# ***FINAL ENVIRONMENTAL IMPACT REPORT***

## ***10000 Santa Monica Boulevard Project***

***ENV-2011-0540-EIR***

**January 2012**

2121 S Towne Centre Place - Suite 130 Anaheim CA 92806 Off 714.634.3701 Fax 714.634.3711	CRESCENT-1-01	<b>TRANSECT 4 SEISMIC SECTION INTERPRETATION</b>	
	DECEMBER 2011	PROPOSED TOWER DEVELOPMENT LOS ANGELES, CA	<b>FIGURE 8</b>

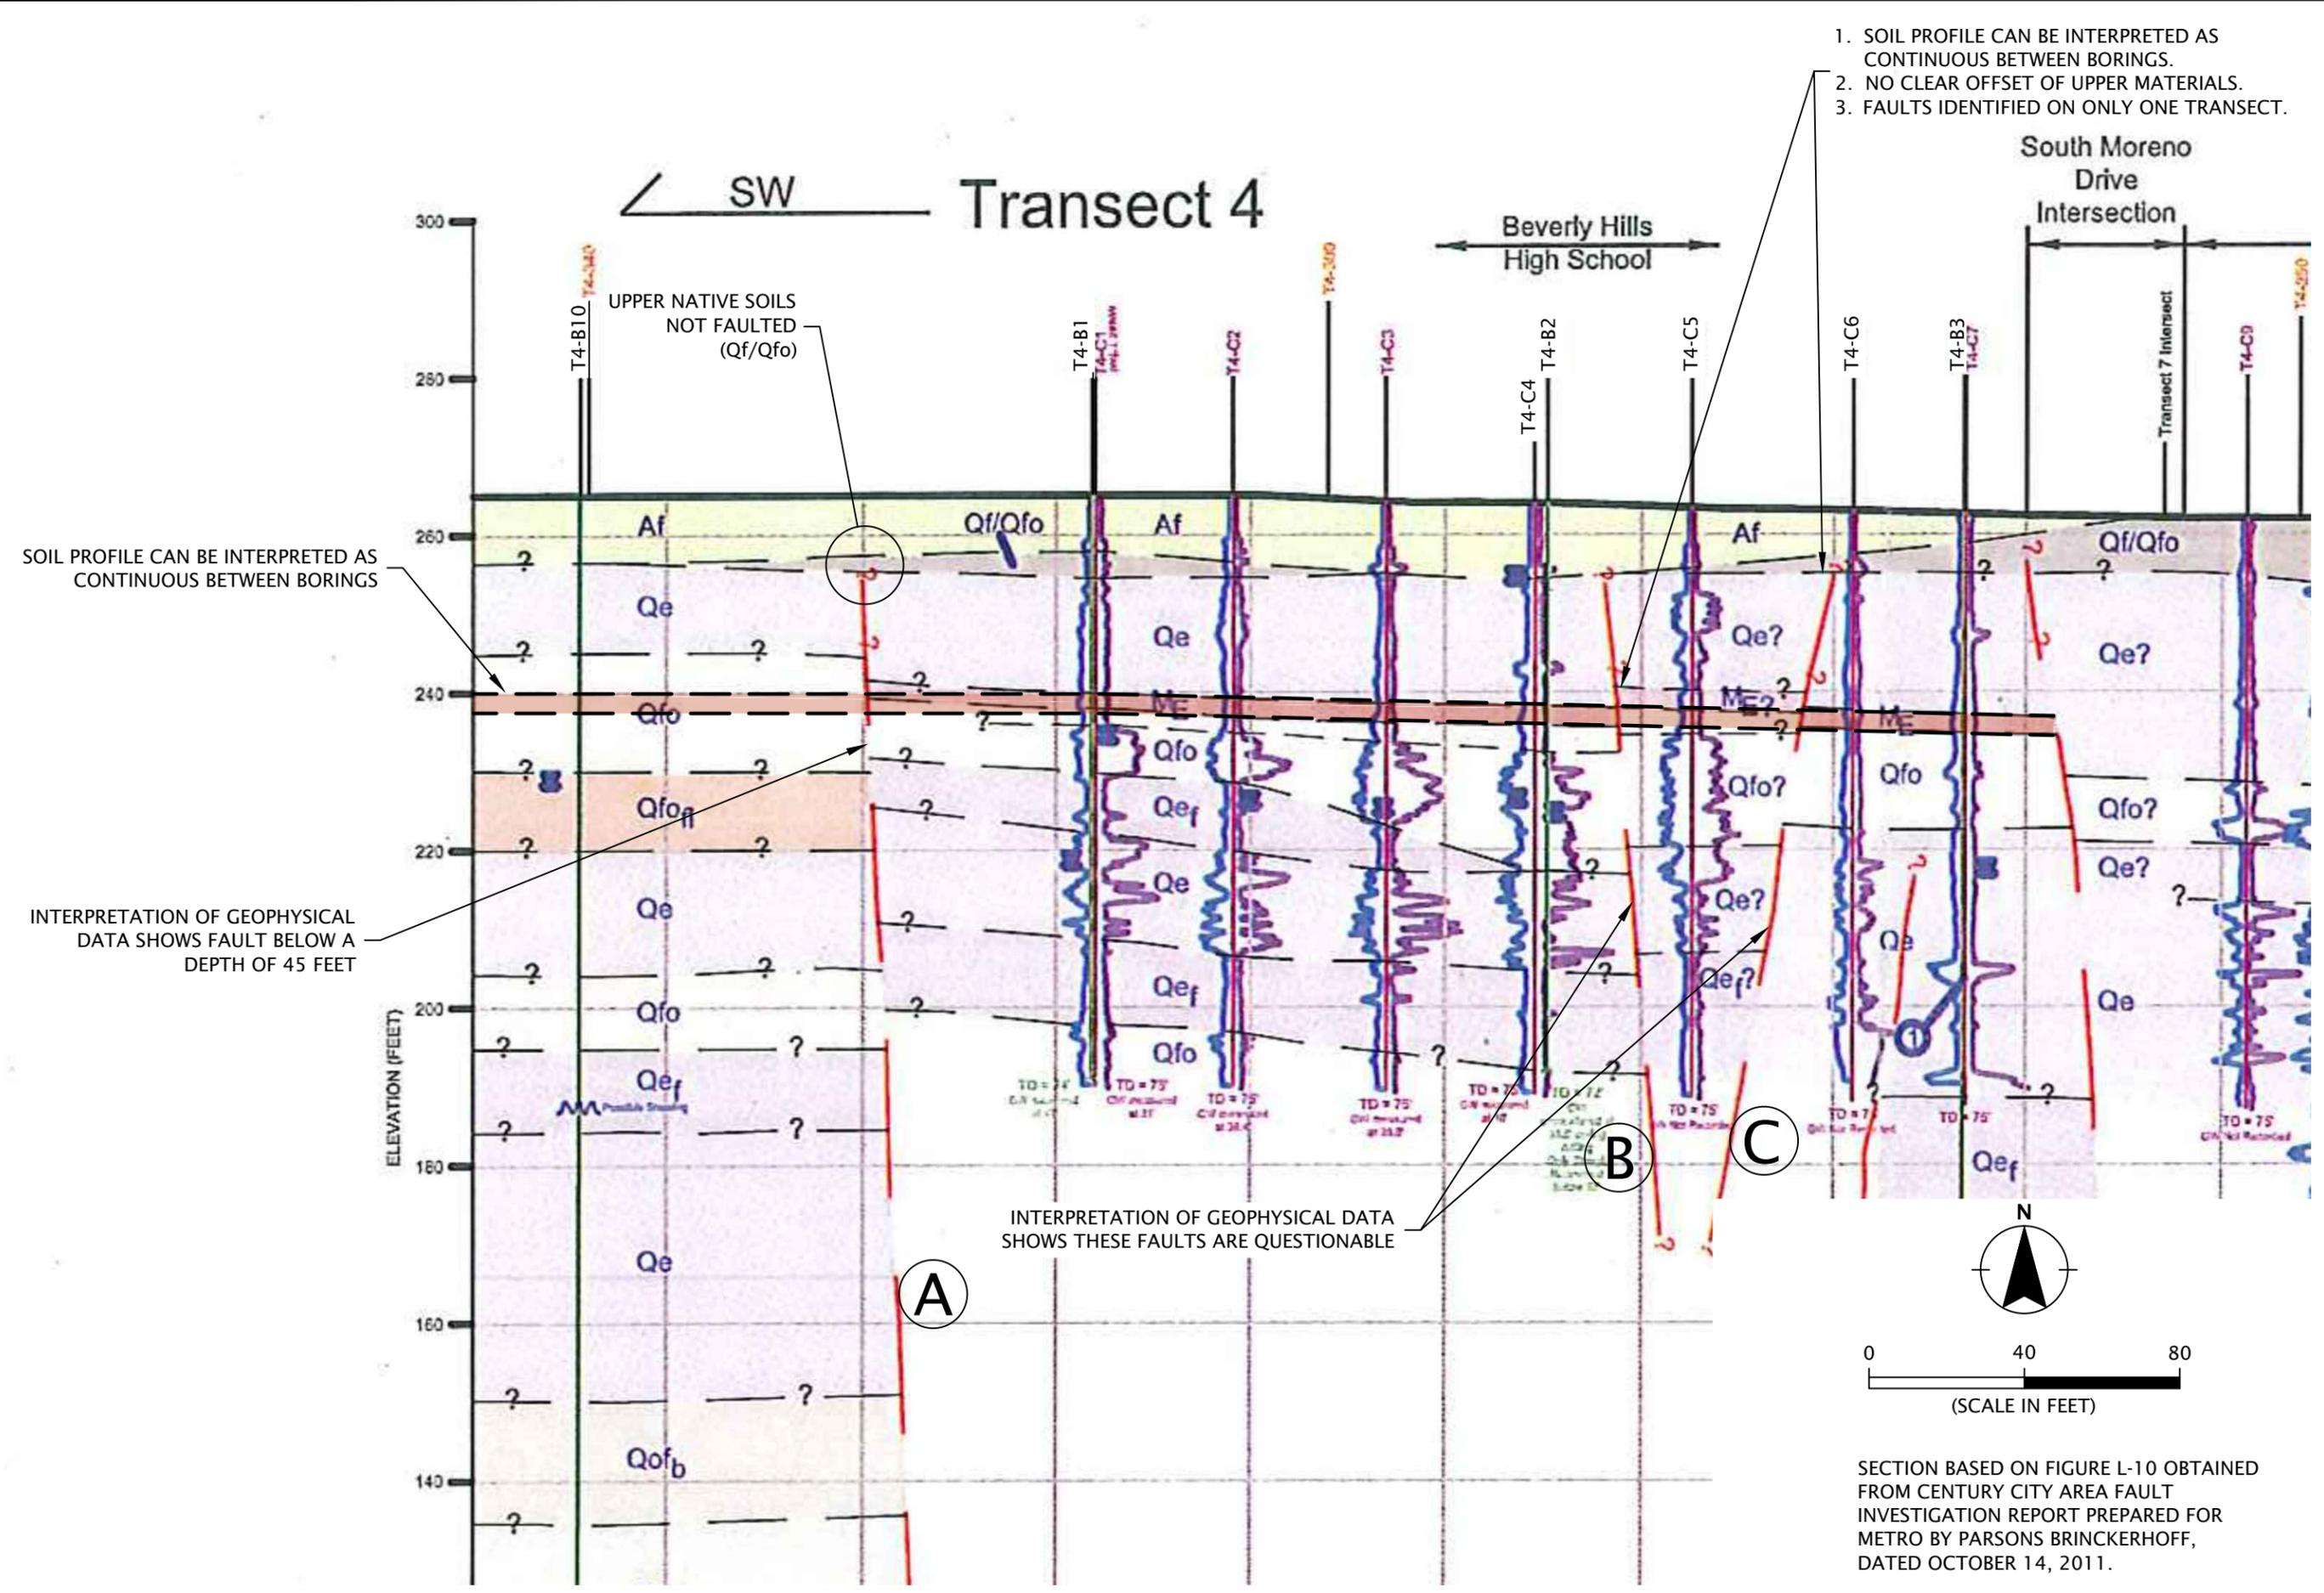
Similar to the seismic reflection data shown in METRO's Transect 2E, the seismic reflection data in Transect 4 also shows an anomaly, which is a hypothesized fault, at a depth of 45 feet BGS or greater. Figure 8, Transect 4 Seismic Section Interpretation (METRO's Appendix D - Figure 38), shows the interpretation of their seismic reflection data along Transect 4.

As shown on Figure 8, Postulated Faults B and C are queried in METRO's seismic reflection interpretation and are not shown to extend within the upper 25 to 35 feet of the surface.

METRO's seismic reflection data identifies Faults B and C as anomalies that are questionable faults and clearly states that additional surveys would be necessary to determine if they exist, as shown on Figure 8. The seismic reflection data shows that these questionable anomalies are present below a depth of 35 feet BGS (Postulated Fault B) and below a depth of 25 feet BGS (Postulated Fault C).

CRESCENT-1-01	SITE PLAN	FIGURE 10
DECEMBER 2011	PROPOSED TOWER DEVELOPMENT LOS ANGELES, CA	
 2121 S Towne Centre Place - Suite 130 Anaheim CA 92806 Off 714.634.3701 Fax 714.634.3711

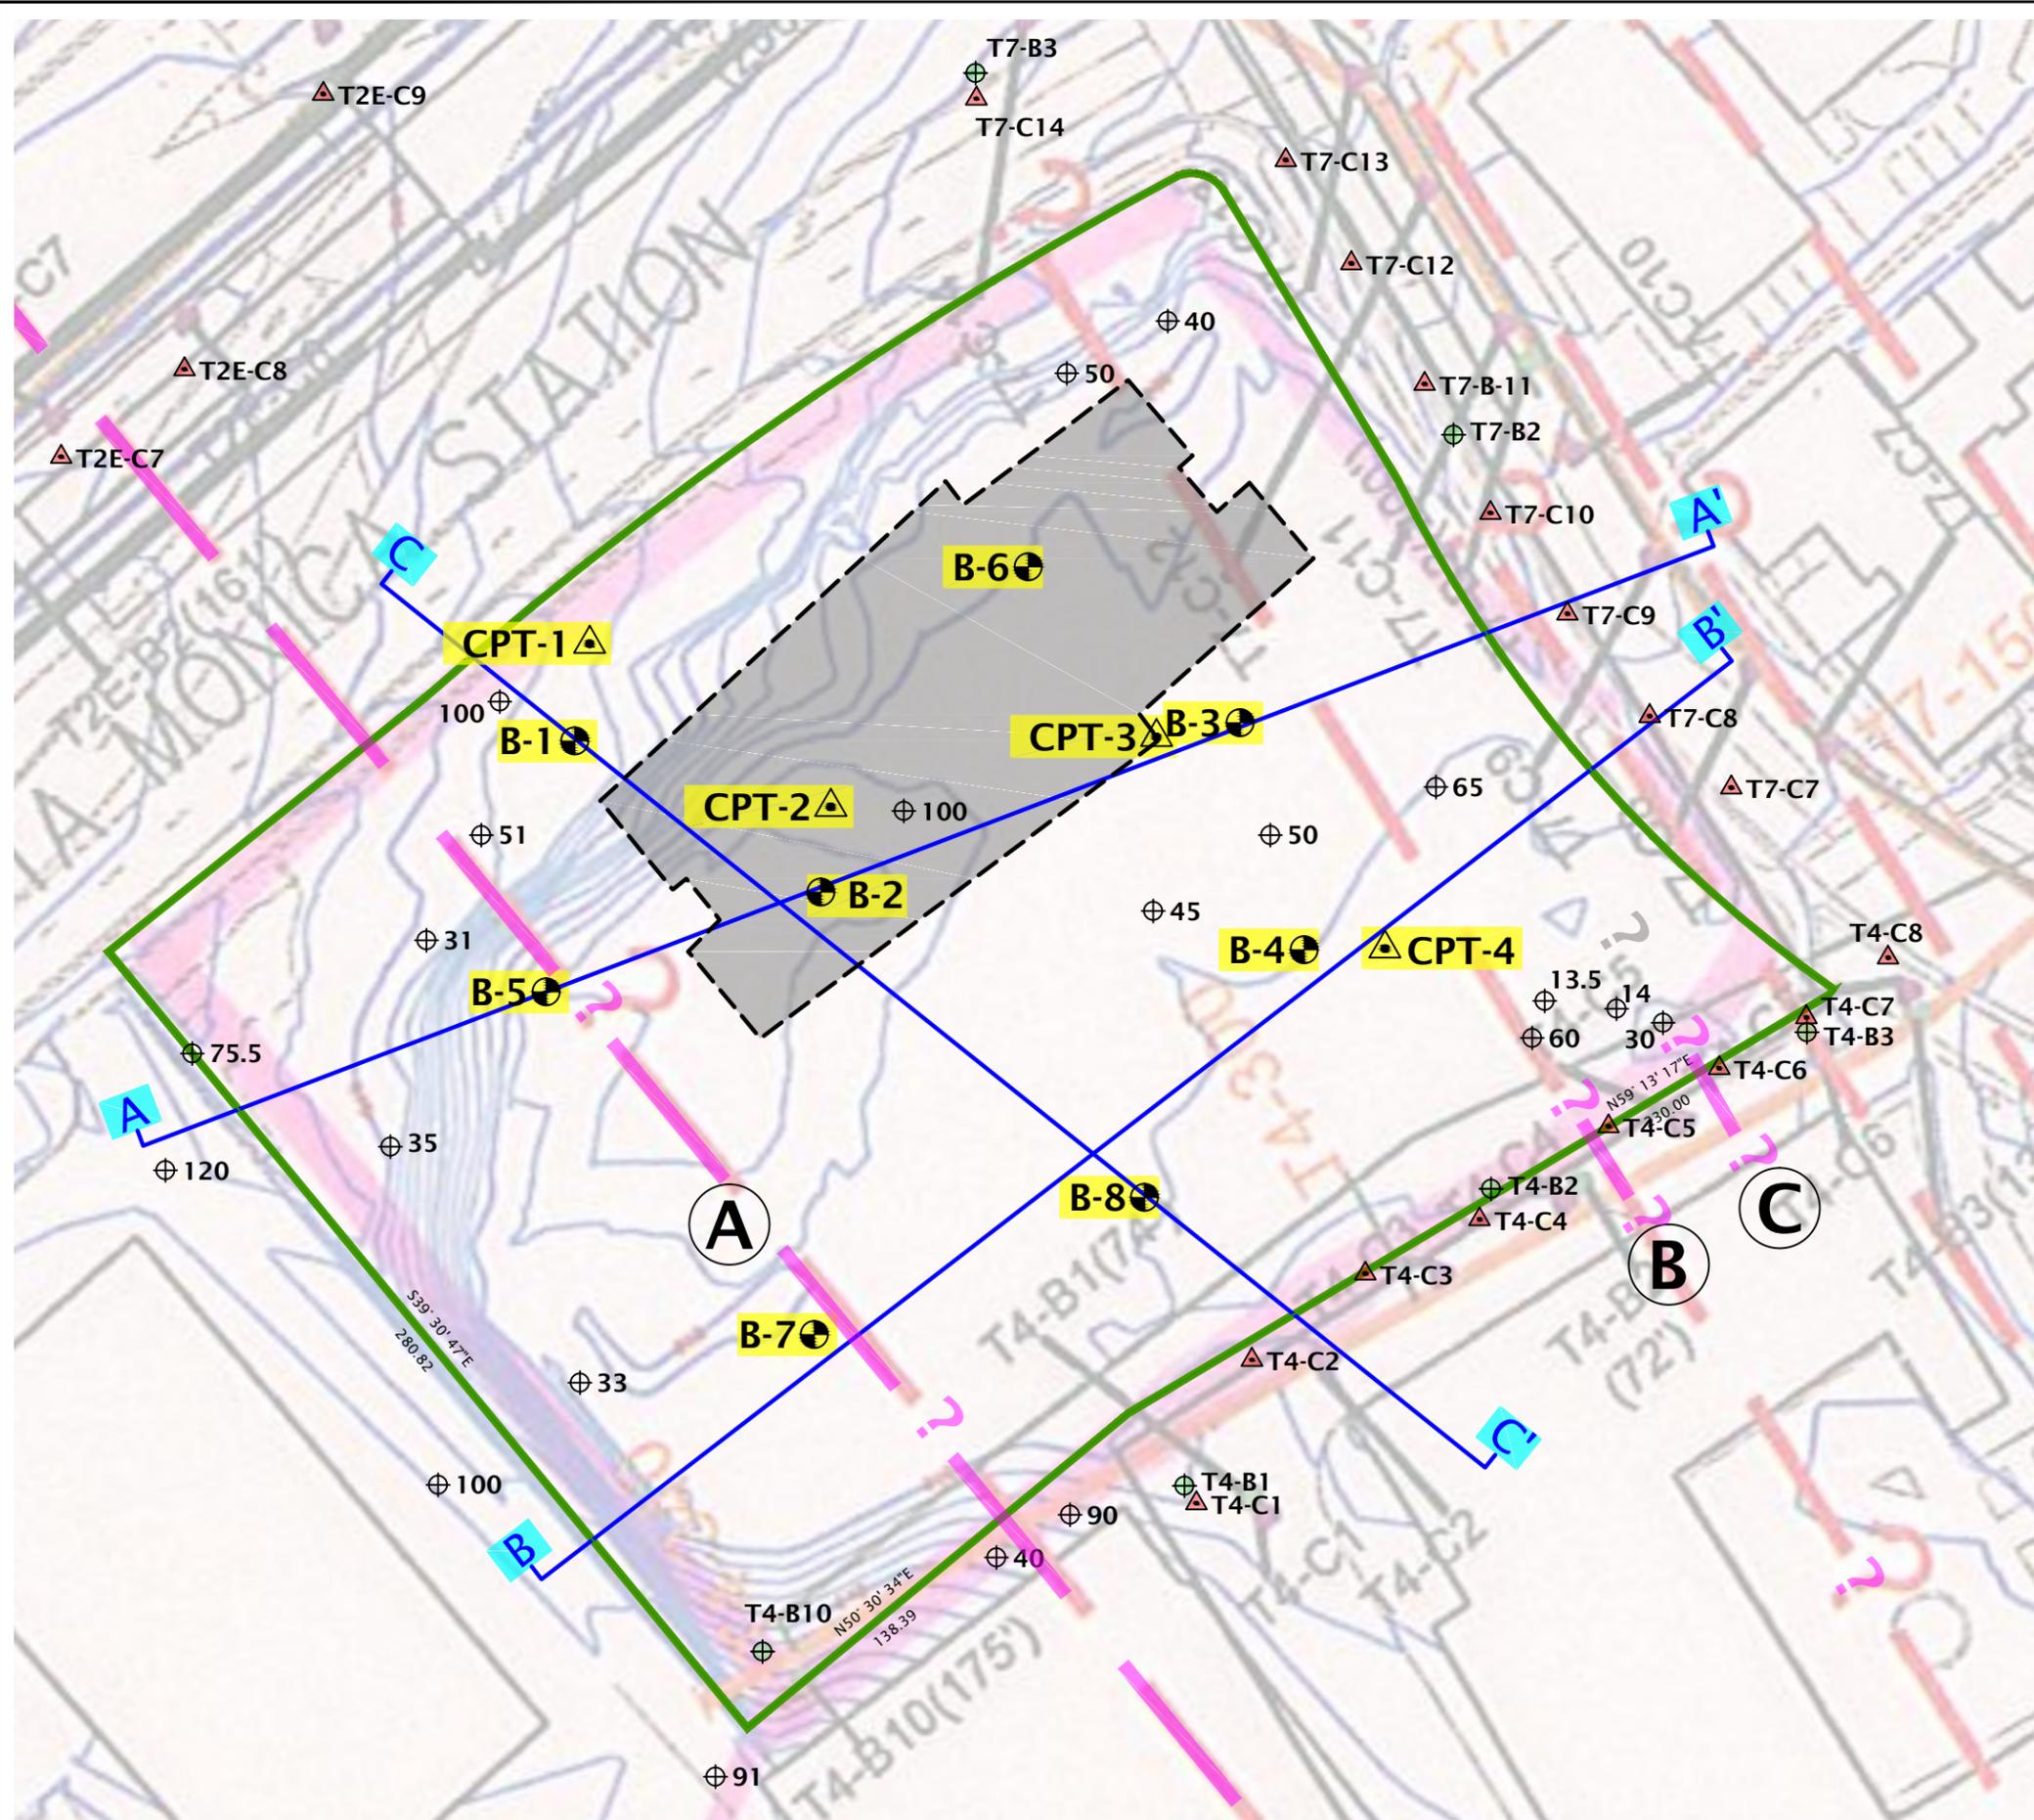
The locations of METRO's prior borings and the current site-specific borings are shown on Figure 10, Site Plan.
